Project			
Name:	Allison Way Apartments		
Address(es):	398 Stacy Allison Way & 3801 Hooper Street, Woodburn, OR 97071		
Tax Lot #(s):	052W14 02000, 02100 & 02300		
Applicant			
Name:	Eugene Labunsky	Title:	President
Phone:	503-989-1613	Firm:	West Coast Real Estate Holdings
Mailing Address:	25030 SW Parkway Ave, Suite 110; Wilsonville, OR 97070		
Email:	eugenel.wchs@gmail.com		
Applicant's Representative/Project Manager			
Name:	Doug Hamilton	Title:	Project Manager
Phone:	503-228-2840 ext 111	Firm:	Leeb Architects
Mailing Address:	308 SW 1st Ave, Suite 200; Portland, OR 97204		
Email:	dhamilton@leebarc.com		
Landowner			
Name:	Stacy Allison Way Holdings, LLC	Title:	
Phone:	503-989-1613	Firm:	West Coast Real Estate Holdings
Mailing Address:	25030 SW Parkway Ave, Suite 110; Wilsonville, OR 97070		
Email:	eugenel.wchs@gmail.com		
Architect			
Name:	see applicant's representative	Title:	
Phone:		Firm:	
Mailing Address:

Modification of Condition of Approval (EX2)

Written Narrative Detailing
"Existing" Stacy Allison Way - Street Improvements
Project area located adjacent to Phase 1 - Tax Lot 052W14-02300
Together with: "Extension" of Stacy Allison Way – Construction
Project area located

EXHIBIT C

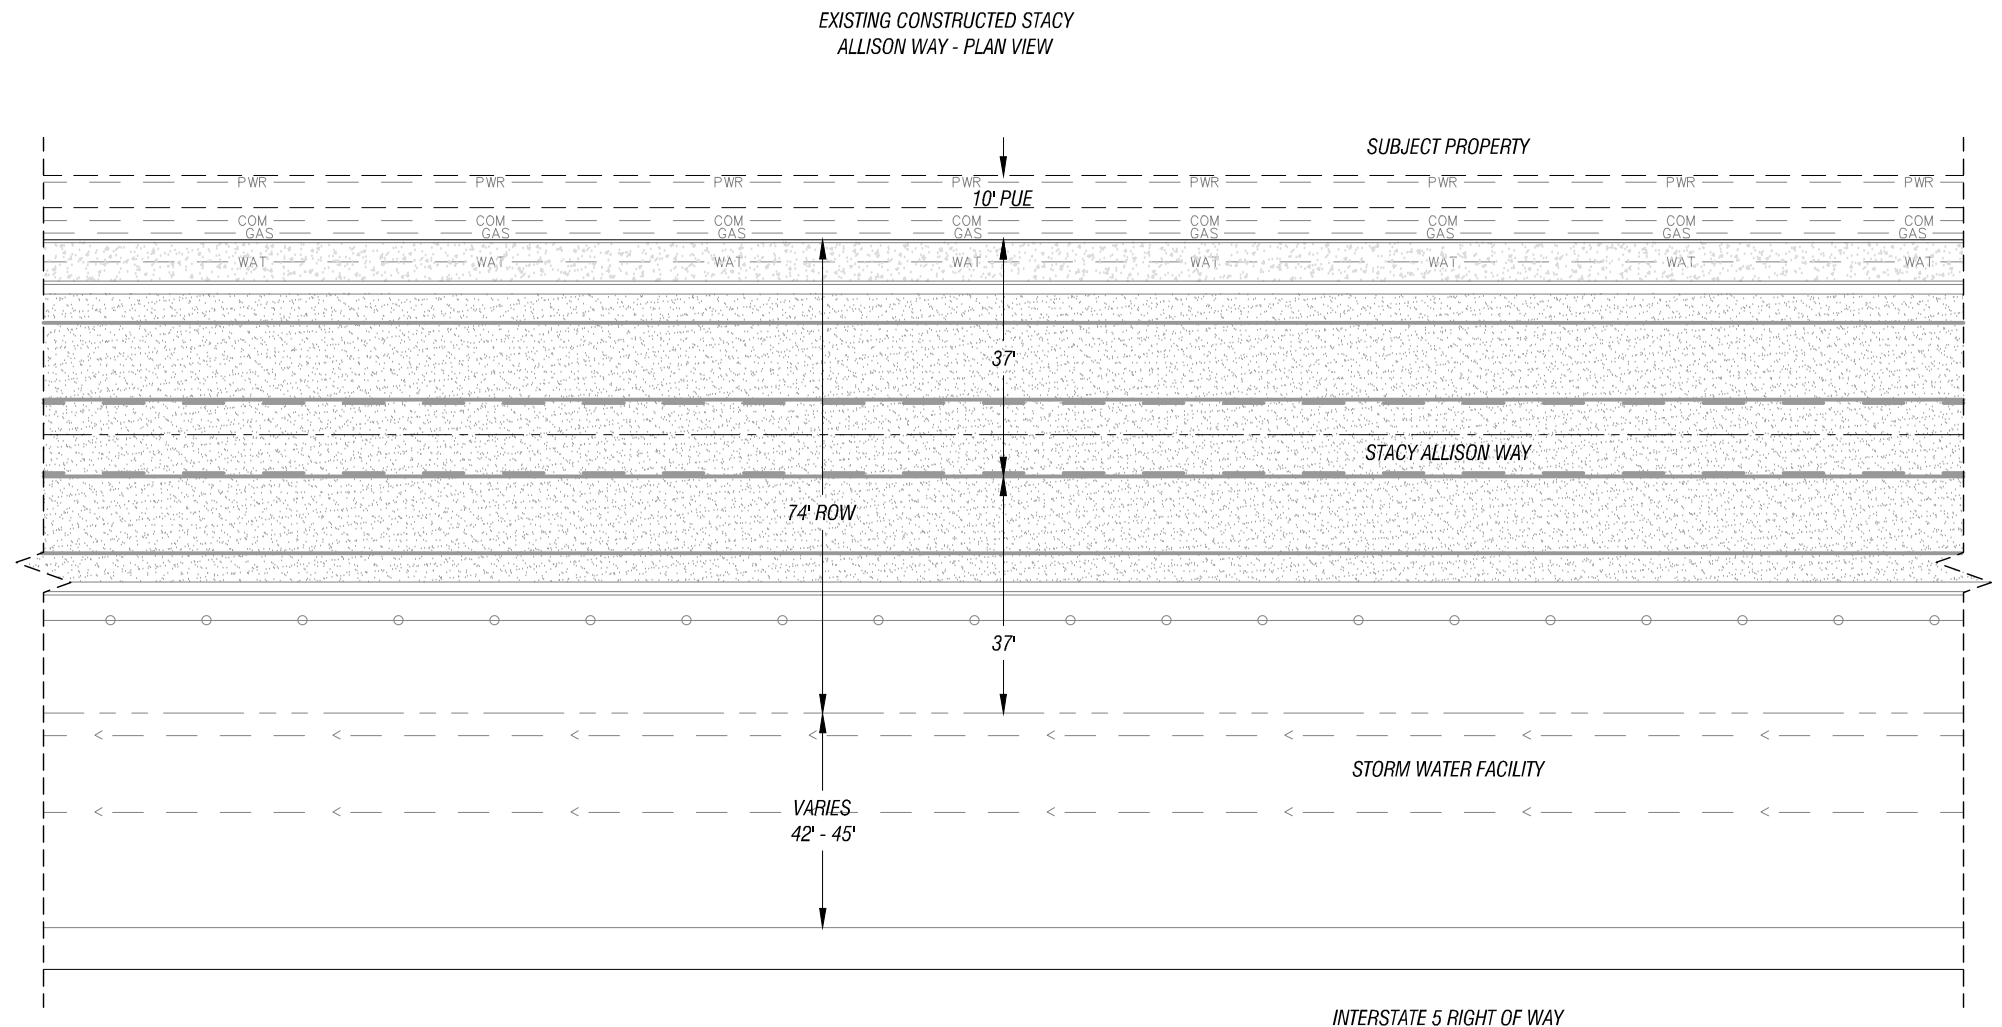
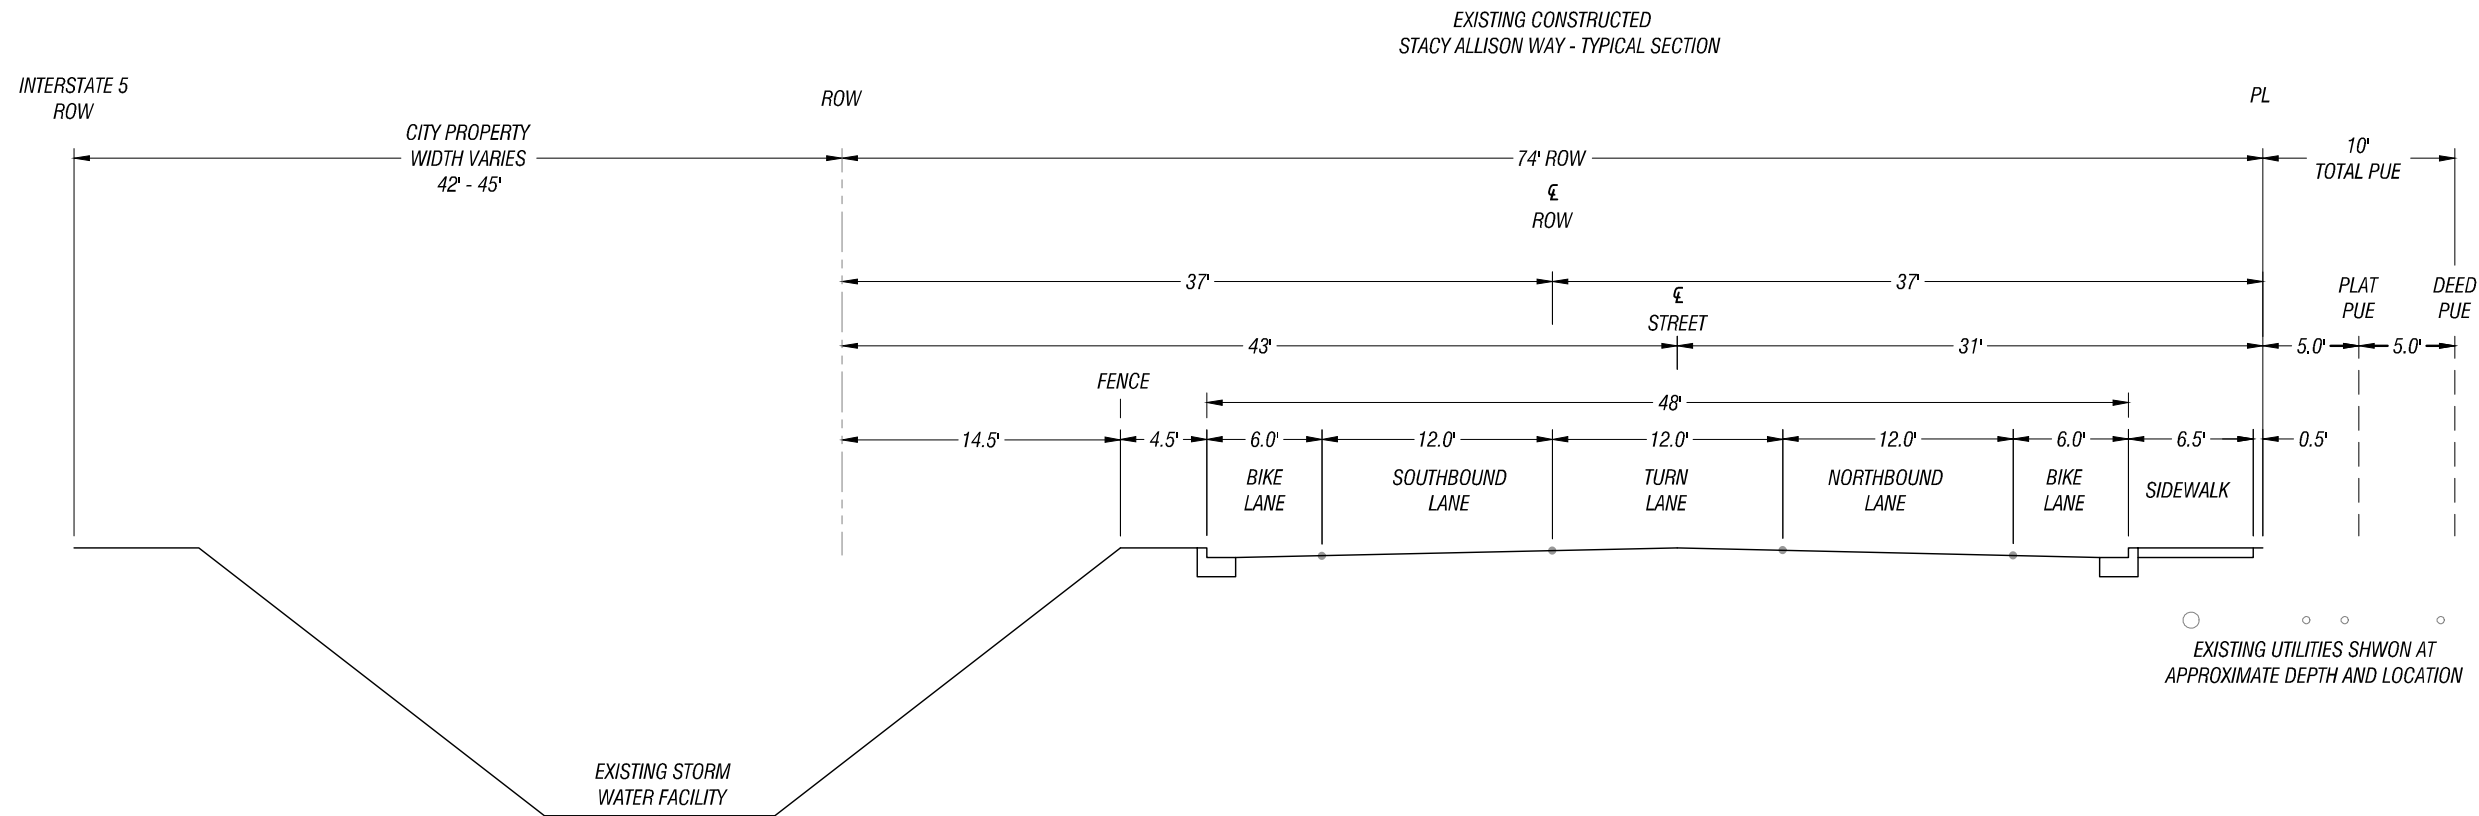
The existing constructed street improvements of Stacy Allison Way does not meet current City of Woodburn Standards. See Exhibit C – Existing Stacy Allison Way Typical Section. This section shows clearly how the City has deviated from the standard to the current constructed street section. This has allowed the City to use of a large portion of the City ROW for a storm water facility. The City also owns the tract of land between Interstate 5 and the Stacy Allison ROW. This tract together with the additional ROW are being utilized as regional storm water facility.

This deviation has reduced the available width for street improvements within the ROW. The current constructed section removes the southbound sidewalk completely and additionally reduces the planter strip width. Furthermore, this deviation also removes the northbound planter strip completely.

EXHIBIT D

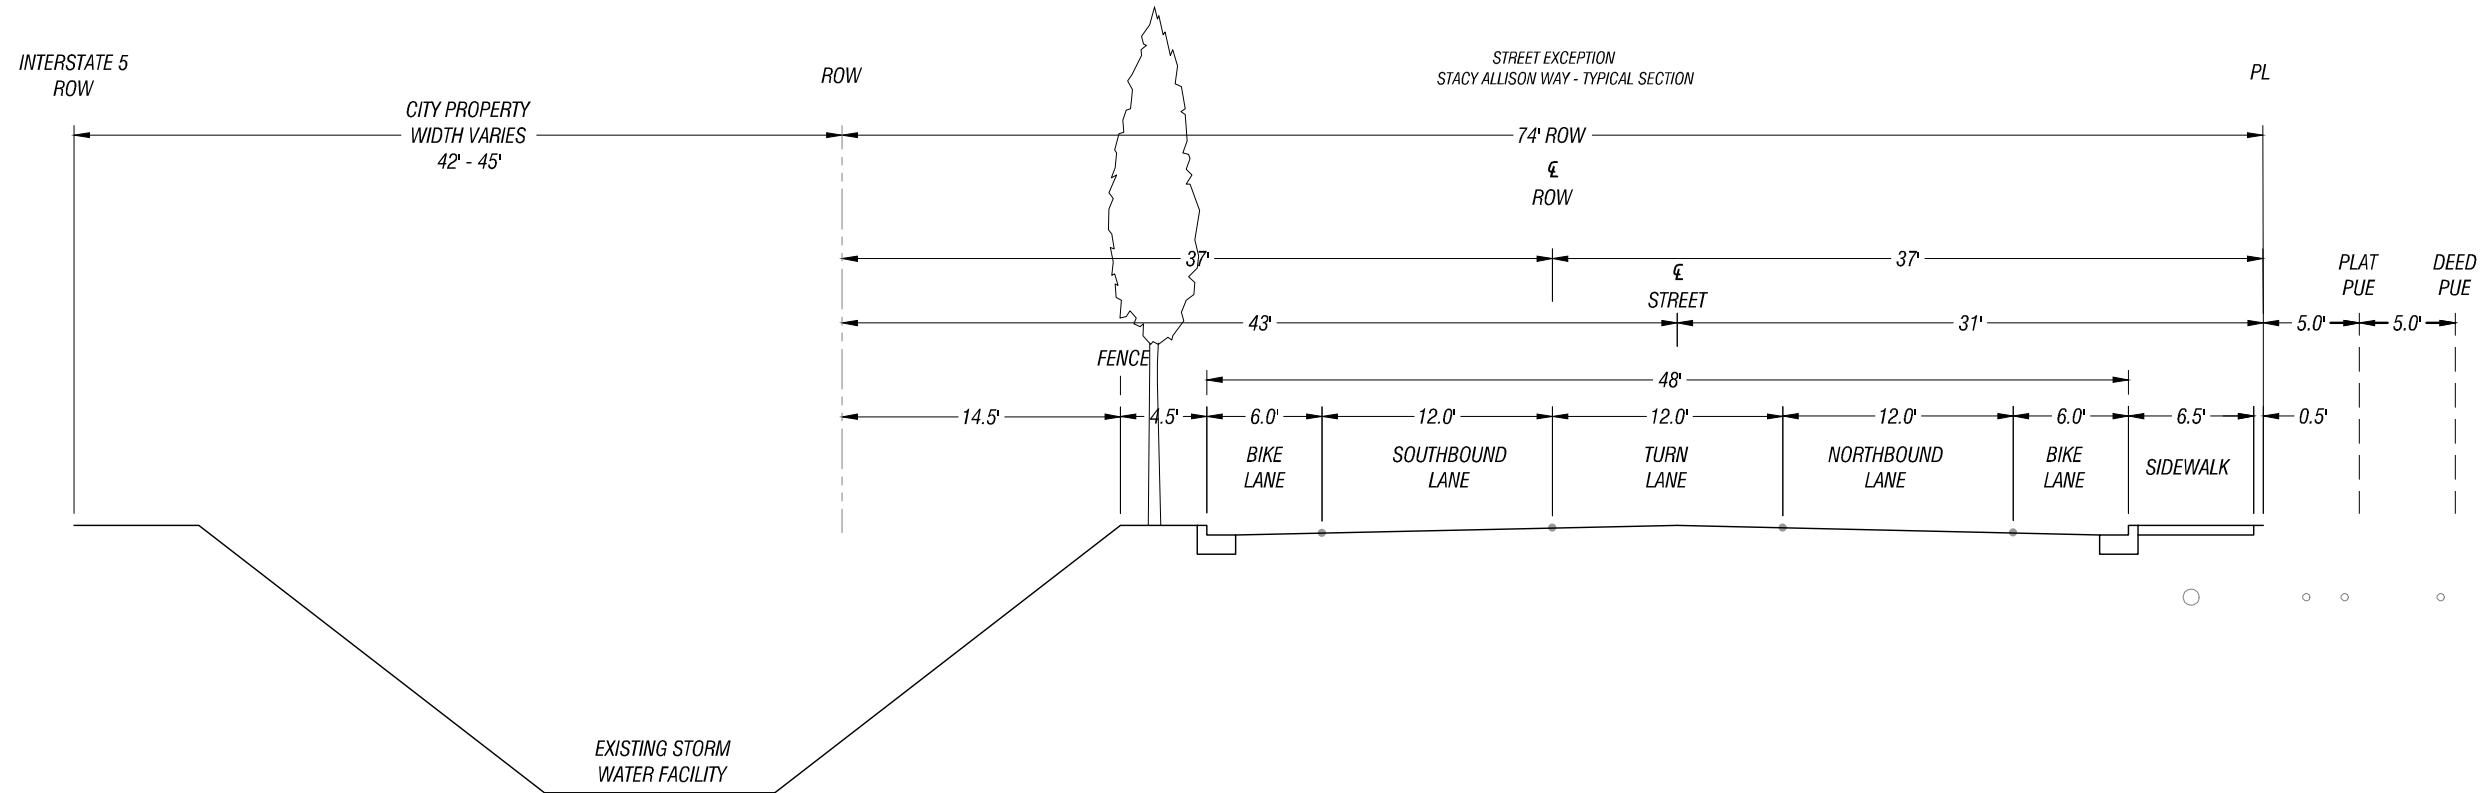
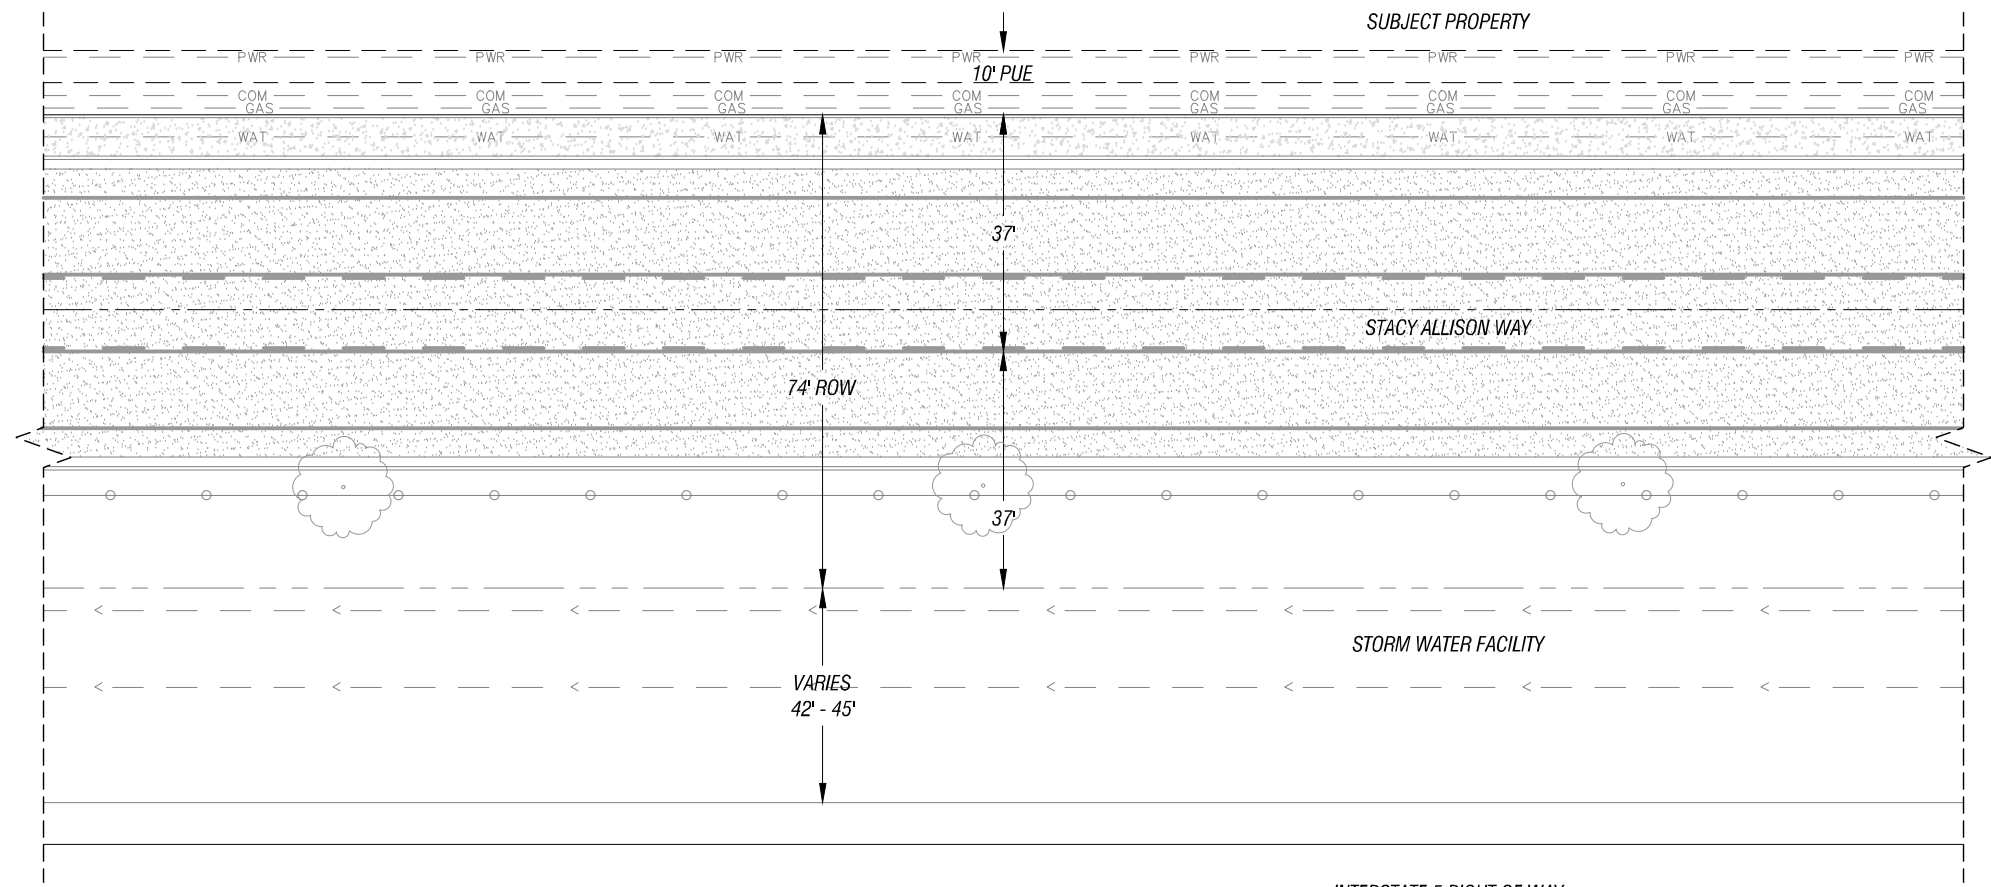
In summary we requested/proposed, to maintain the current street section for Stacy Allison Way for the entirety of proposed development. See Exhibit D – Proposed Stacy Allison Way Typical Section. This request is in line with the guidance from City Engineering Staff to date. As a mitigation measure for the lack of a northbound planter strip in the current street section configuration, we proposed planting street trees along the southbound planter area of the roadway and adjacent to the stormwater facility to the west side of Stacy Allison Way. An arborist memo was submitted to provide the City with options for trees with a small crown ratio to minimize concerns about tree planting so near the street improvements and existing fence along existing storm water facility.
